TGB TREE CONSULTING

TREE PLANTING REVIEW

Bismillah House, Brookers Hill, Shinfield, Reading, RG2 9BX

TGB432.V1.0-Tree Planting Review

Appendix 1 – Tree Planting Plan Review

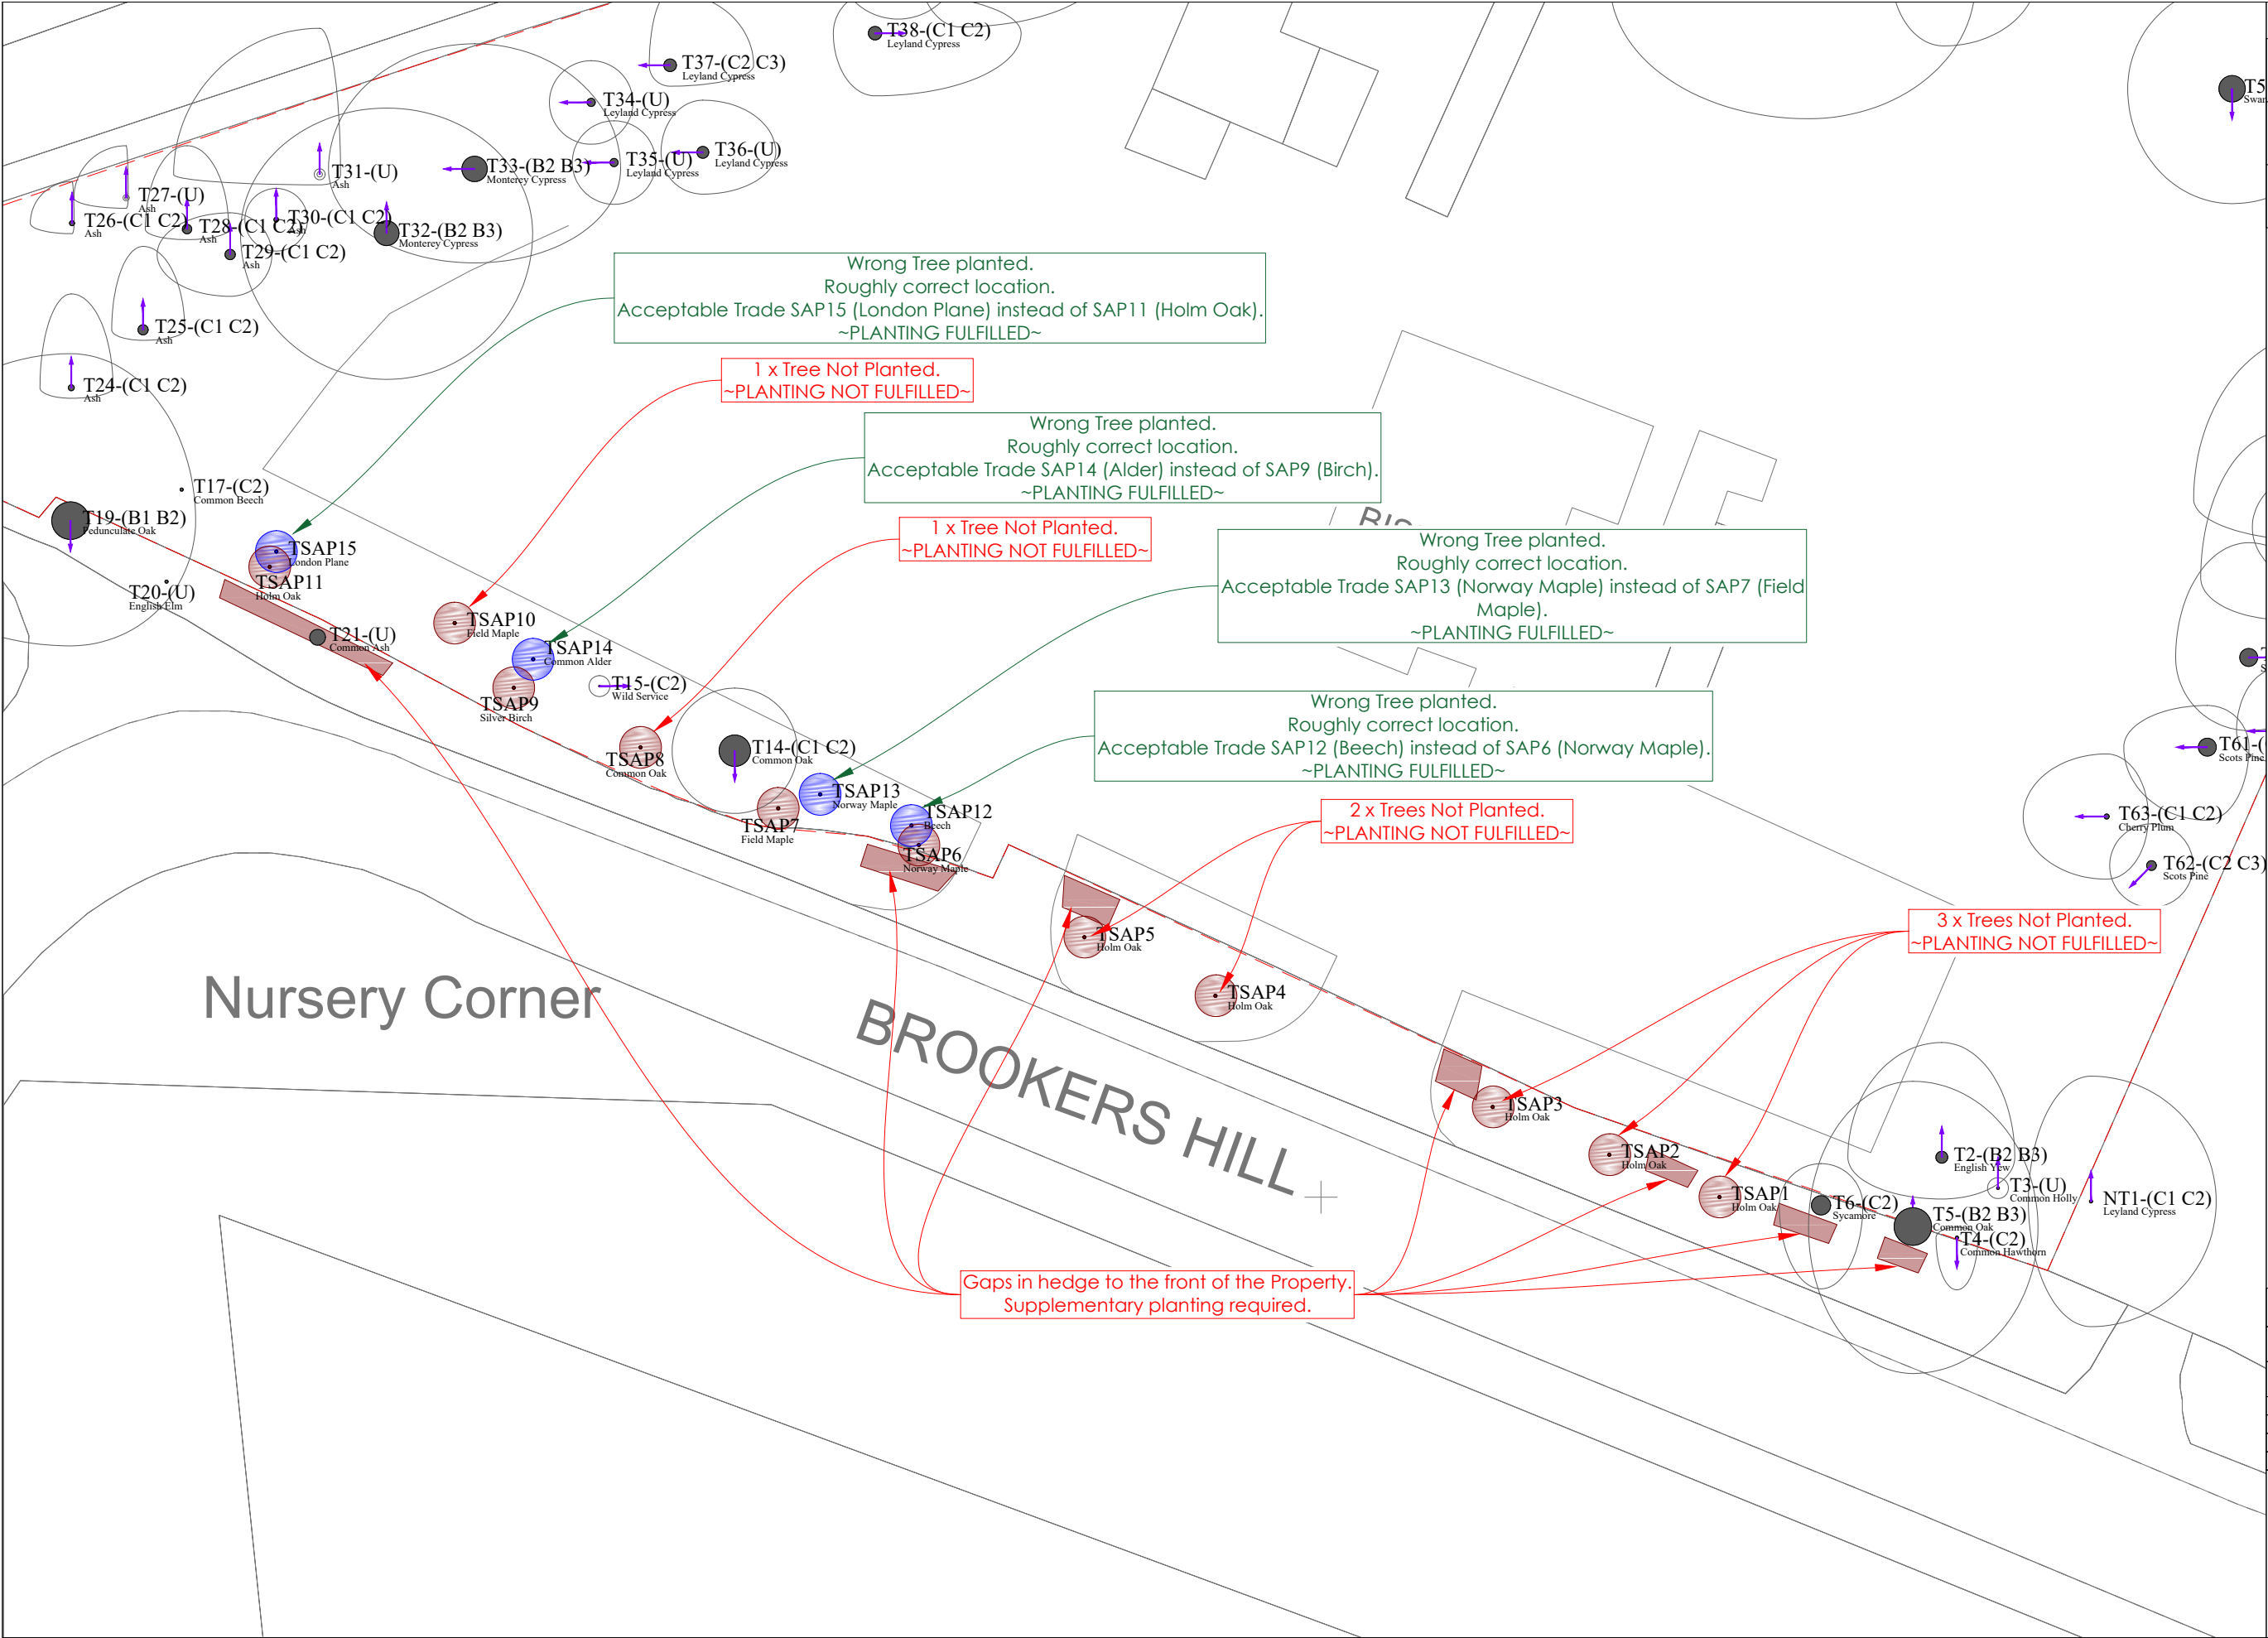
SAP9	Silver Birch (<i>Betula pendula</i>)	NO	SAP14 (Alder) has been planted in this location. The specimen has a 14cm girth at 1.2m above ground level.	This is seen as an acceptable replacement tree, not the approved tree specimen, but in the correct location and suitable size. (See SAP14 below). No Further Action Required.
SAP10	Field Maple (<i>Acer campestre</i>)	NO	NA	Plant 1 x Field Maple (<i>Acer campestre</i>)
SAP11	Holm Oak (<i>Quercus ilex</i>)	NO	SAP15 (London Plane) has been planted in this location. The specimen has a 22cm girth at 1.2m above ground level.	This is seen as an acceptable replacement tree, not the approved tree specimen, but in the correct location and suitable size. (See SAP15 below). No Further Action Required.
HEDGE12	Mixed native broadleaf	NO	Parts of the hedge at the front have grown to form a hedge consisting of a mixture of species. Within the hedge, there are still various patches that require supplementary planting.	Carry out supplementary planting of whips in gaps to bolster the hedge.

Below is a list of trees that have been planted on site, but don't fully conform with the planting plan.				
SAP12	Beech (<i>Fagus sylvatica</i>)	YES	Planted in the location of SAP6. The specimen has a 12cm girth at 1.2m above ground level. In good condition.	Suitable Replacement No Further Action Required.
SAP13	Norway Maple (<i>Acer Platanoides</i>)	YES	Planted in the location of SAP7. The specimen has a 20cm girth at 1.2m above ground level. The tree is in good condition. The tree has been planted slightly too deep.	Suitable Replacement Reduce the surrounding soil level within 2m of the stem by approximately 50mm.
SAP14	Alder (<i>Alnus glutinosa</i>)	YES	Planted in the location of SAP9. The specimen has a 14cm girth at 1.2m above ground level. The tree is in fair condition. The tree has been planted slightly too deep. Minor bleeds on the stem.	Suitable Replacement Reduce the surrounding soil level within 2m of the stem by approximately 50mm. Monitor in the future.

SAP15	London Plane (<i>Platanus X hispanica</i>)	YES	Planted in the location of SAP11. The specimen has a 22cm girth at 1.2m above ground level. The tree is in good condition. The tree has been planted slightly too deep.	Suitable Replacement Reduce the surrounding soil level within 2m of the stem by approximately 50mm.

- 9.2 The replacement planting has not been carried out in full or to the correct specification; however, it is clear that some attempt has been made to carry it out.

- 9.3 Of the eleven trees that were scheduled to be planted, none of the actual correct trees have been successfully planted.
- 9.4 Instead, I can confirm several new trees have been planted, in roughly the correct location, but of the wrong species, as follows:

- One Beech (SAP12) has been planted instead of a Norway Maple (SAP6).
 - One Norway Maple (SAP13) has been planted instead of a Field Maple (SAP7).
 - Common Alder (SAP14) has been planted instead of a Silver Birch (SAP9).

- One London Plane (SAP15) has been planted instead of a Holm Oak (SAP11).
- 9.5 A total of four replacement trees have been planted (Above). Although the trees are the wrong species, they have been planted in approximately the positions shown in the tree planting plan and have a minimum girth of 12cm, ranging up to 22cm (London Plane).

- 10.1 Accept the four new trees (SAP12, SAP13, SAP14 and SAP15) as acceptable replacement trees, to be counted towards the replacement planting requirement.
- 10.2 Plant the remaining replacement planting in accordance with the approved schedule, comprising 7 trees and 1 hedge planting.

Appendix 2 – Tree Planting Plan

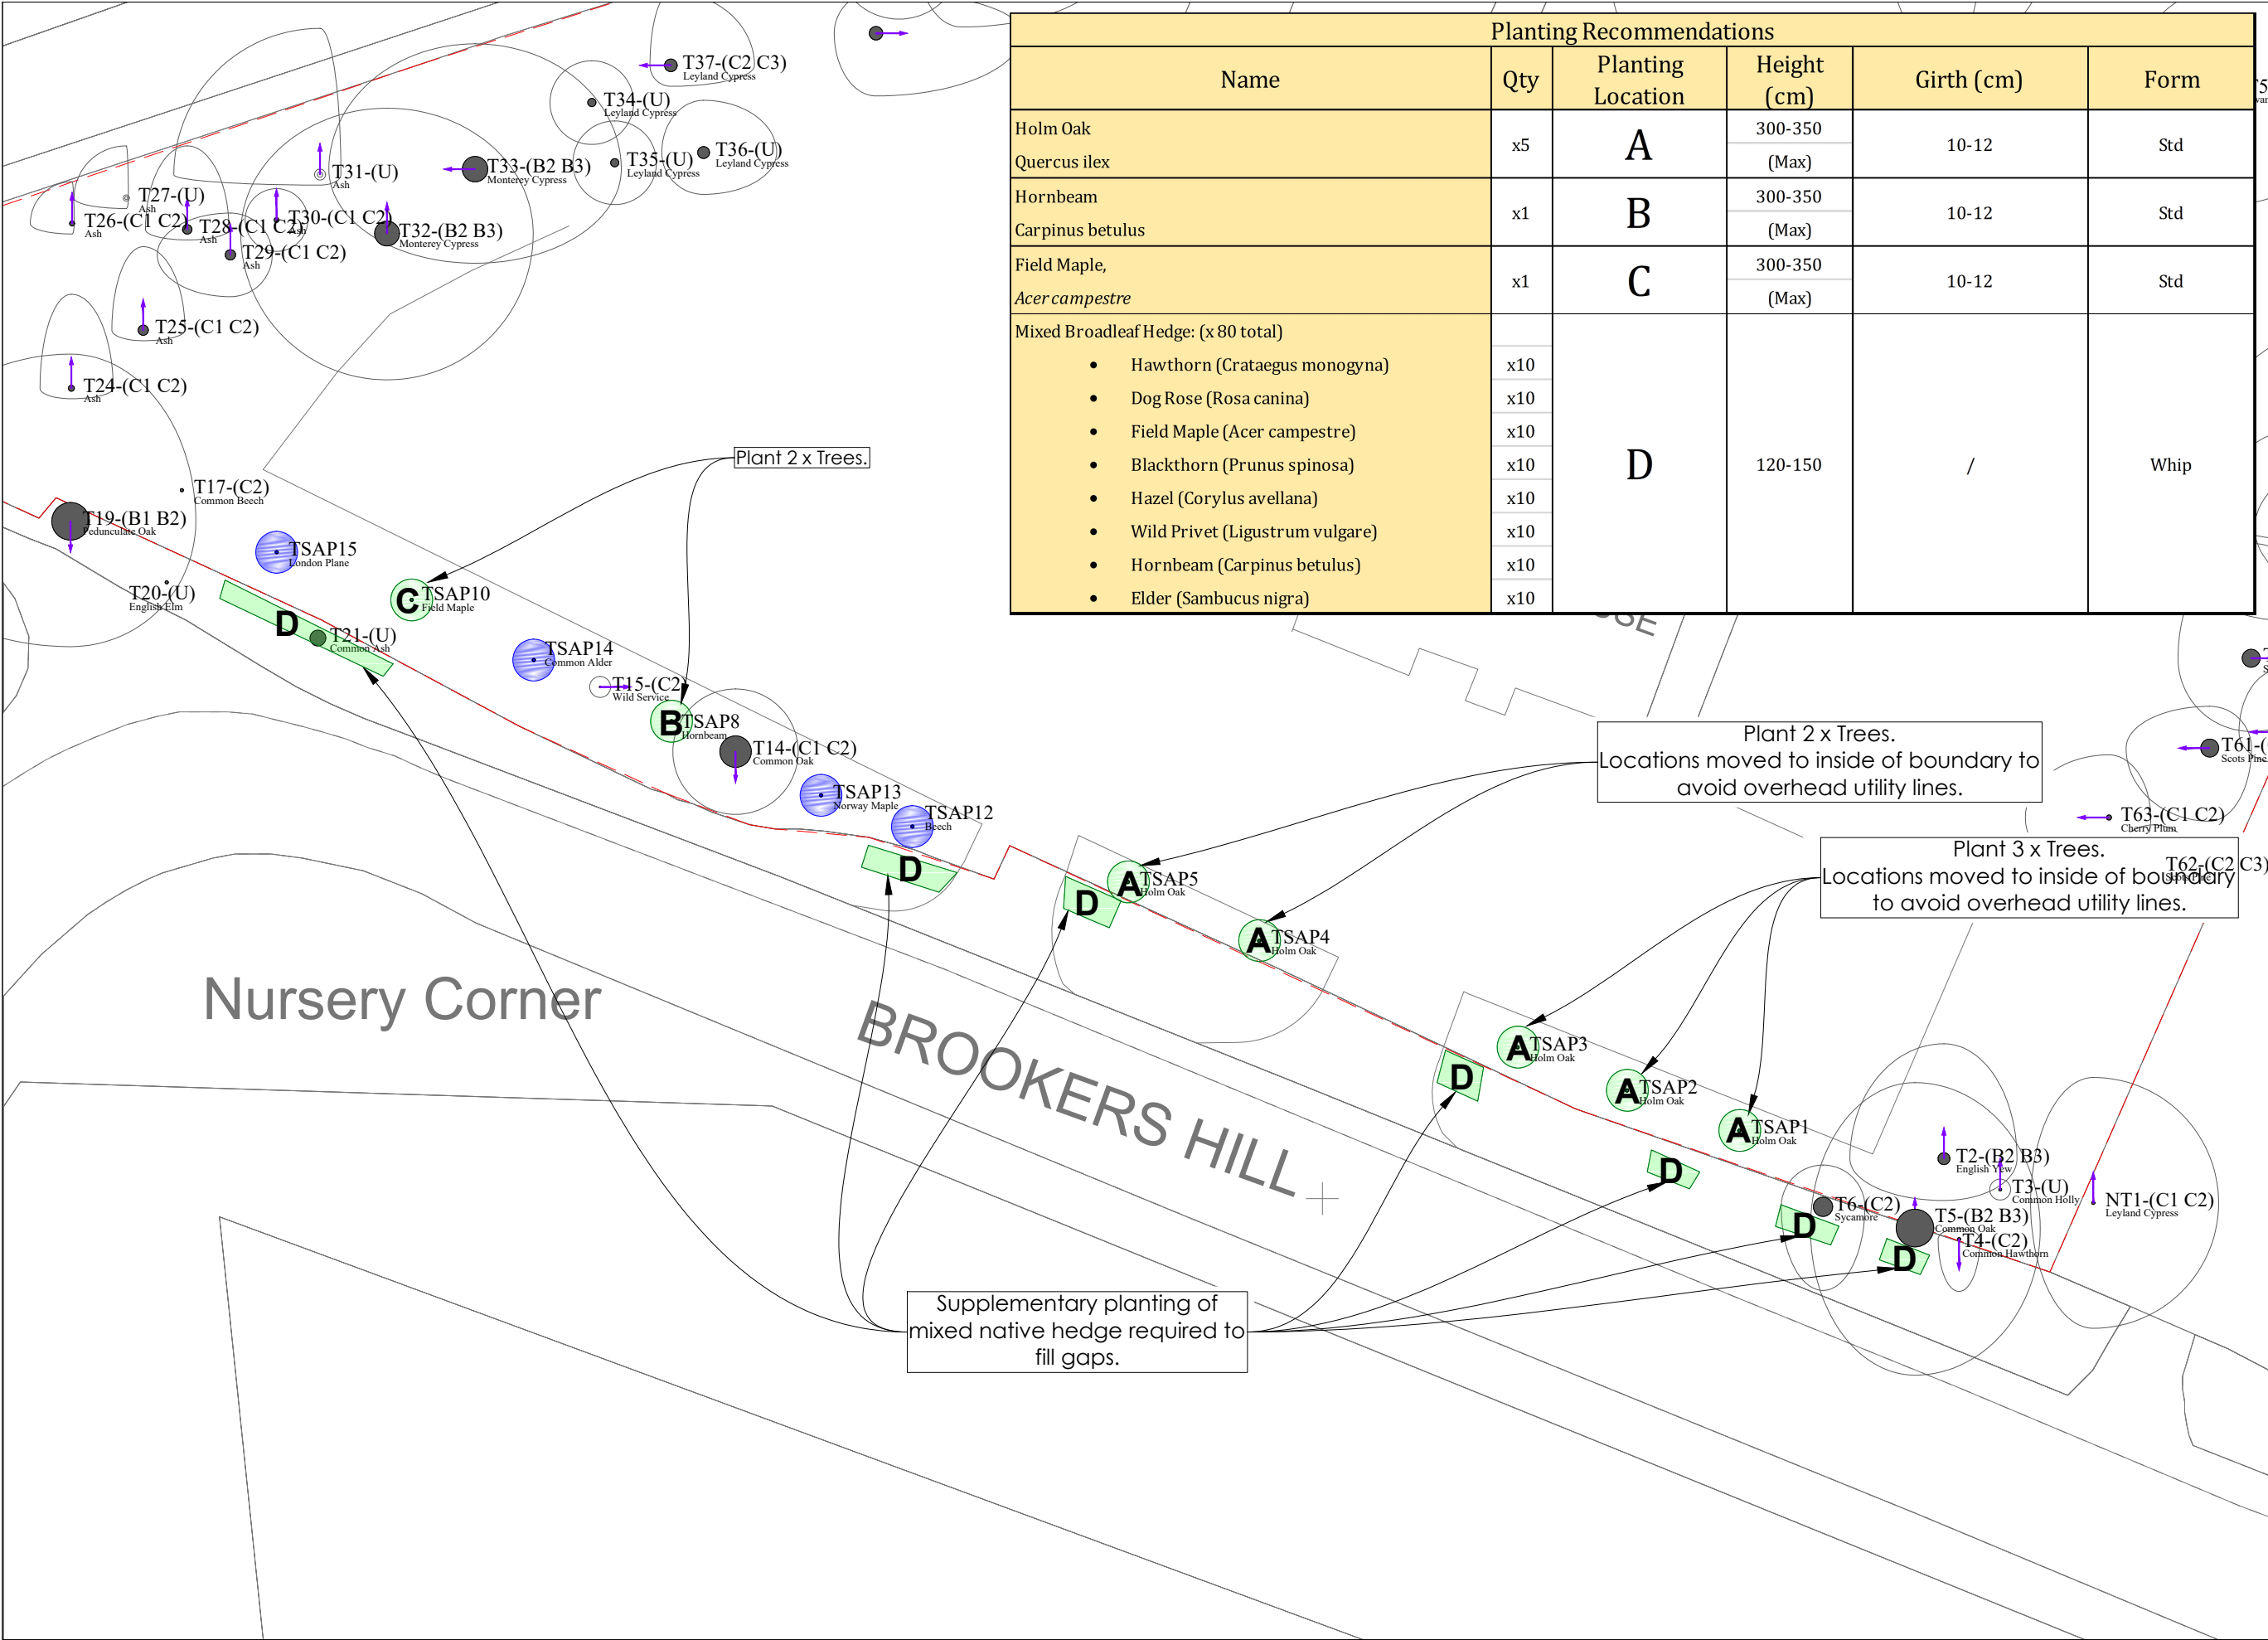
- 9.7 A new planting plan has been created and incorporates these trees (shown in blue) along with trees still to be planted (shown in green).
- 9.8 The hedge at the front of the property still has frequent gaps. The gaps in the hedge require supplementary planting of mixed native whips.

11.1 Below is a list of trees and whips to be sourced and planted in accordance with the updated planting plan.
